MIL-PRF-6106/9C
AMENDMENT 4
10 July 1999
SUPERSEDING
AMENDMENT 3
12 December 1996

PERFORMANCE SPECIFICATION SHEET

RELAY, ELECTROMAGNETIC, CONTINUOUS DUTY, 60 AMP,
3PDT, ENVIRONMENTALLY SEALED

FIGURE 1. Configurations and dimensions.

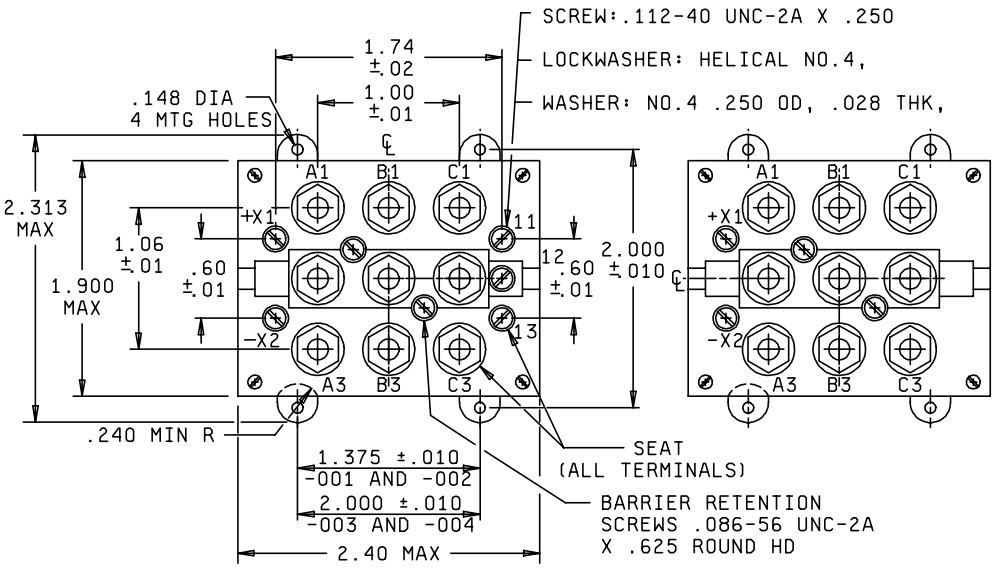
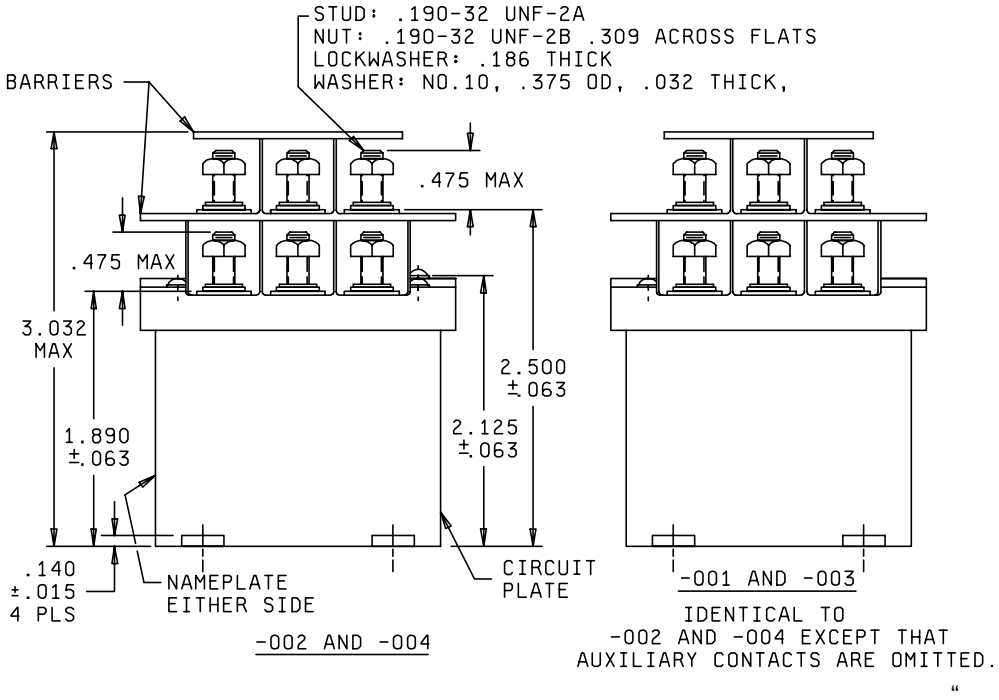
* FIGURE 1, delete and substitute:
